MEMORANDUM FOR: R. C. Knop, Reactor Projects Section 1, RIII

FROM: K. V. Seyfrit, Assistant Director for Technical Programs, ROI, IE

SUBJECT: STUCK ROD MEASUREMENT FOR DAVIS BESSE UNIT NO. 1 (AITS F30001H2)

FIGURE 4.7-2

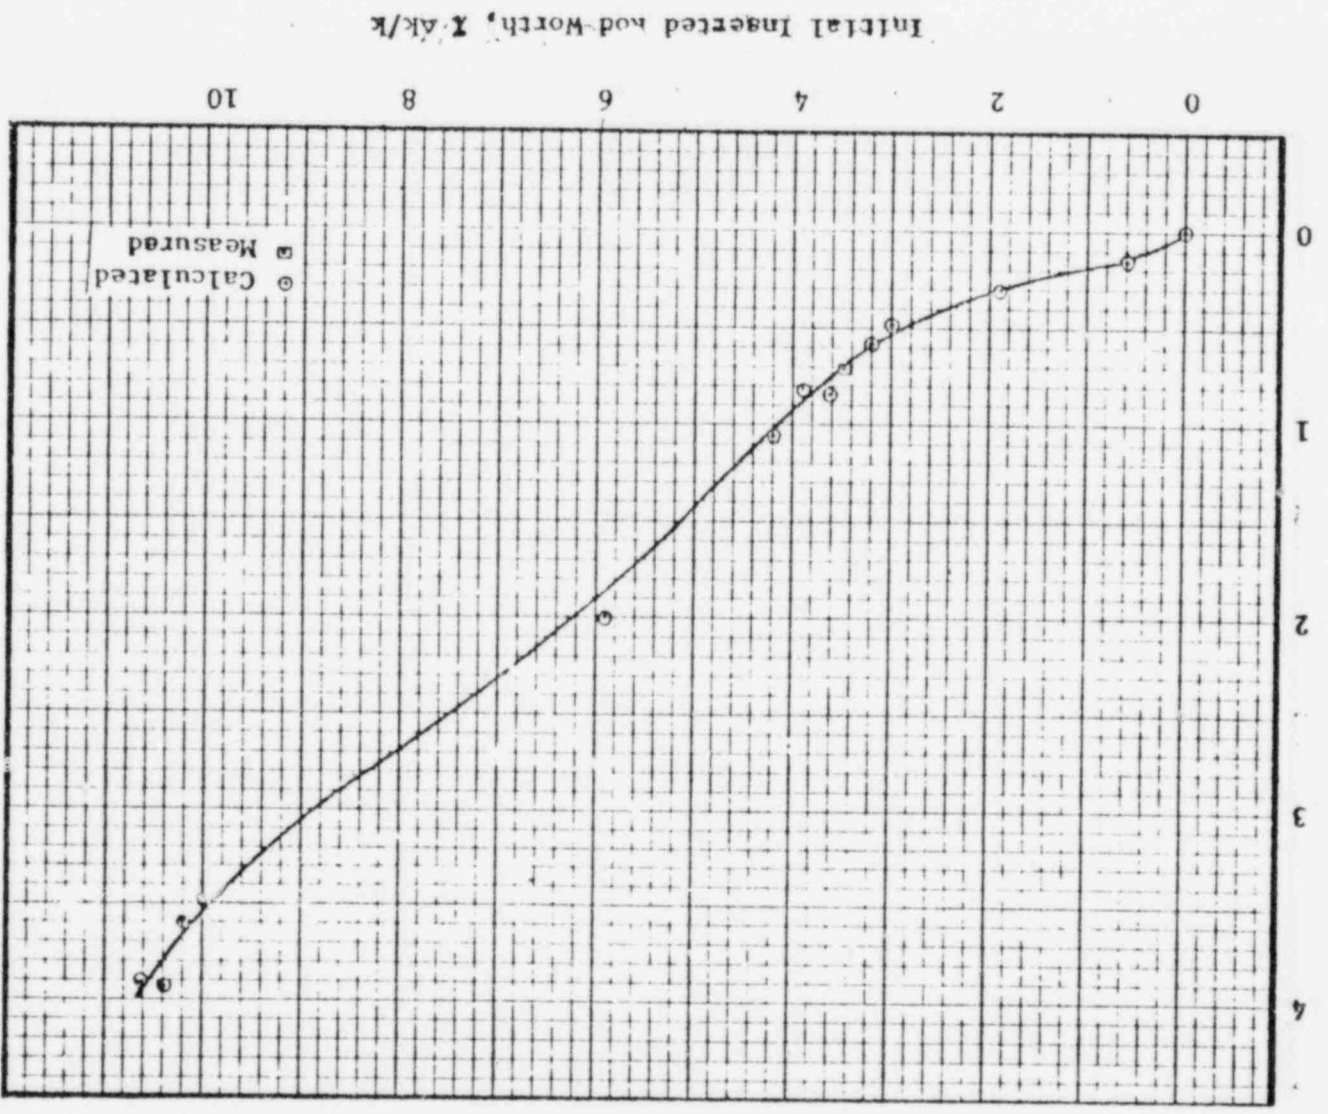
1. Rancho Seco Startup Report
(Figure 4.7-2)
2. Rancho Seco Startup Report
(Section 4.6)
3. Rancho Seco Startup Report
(Table 4.6.1)
